"BEST EFFORT"
 Q 29958 1-12-2012

QTY REQD	ITEM NO	PART OR IDENTIFYING NO	MANUFACTURE OR DESCRIPTION	MATERIAL SPECIFICATION	ITEM NO
ANALYSIS AND TESTING SPECIFIED BY CUSTOMER OR CONTRACTOR (SEE DRAWING FOR PART NUMBER AND QUANTITY) FINISH: XXX-01 .XXX-005 ANGLE: 2-5 DO NOT SCALE DRAWING MATERIAL: 9001-T6-ALUMINUM FINISH: NONE					
SCALE: SEE ABOVE FILENAME: /home/dcc/docs/0970187.pdf					
APPROVALS			DATE		
J. Hozel					
SECRET					
TITLE			LIGO CALIFORNIA INSTITUTE OF TECHNOLOGY MASSACHUSETTS INSTITUTE OF TECHNOLOGY		
SITE			WIRE STANDOFF, SOS		
B			DWG NO: D970187-B-D		
SCALE			SHEET 1 OF 1

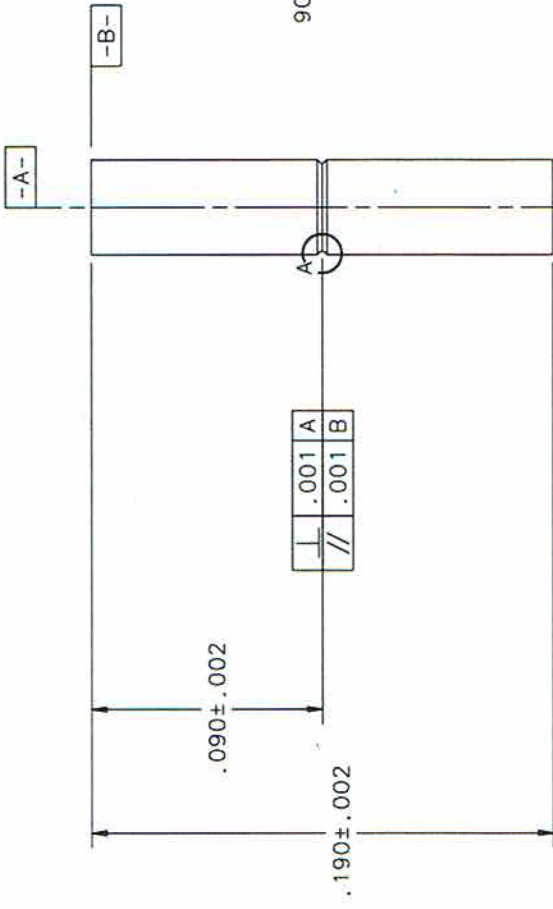
SOS MUSIC WIRE ϕ 0.0017"

CIRCUMFERENTIAL GROOVE
 DETAIL A

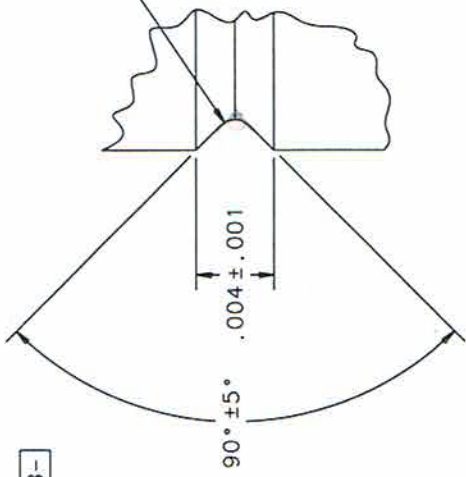
change

*R 0.0005 max
 ± .0002*

*Koji
 1-13-2012*

SAPPHIRE OR RUBY, POLISHED!
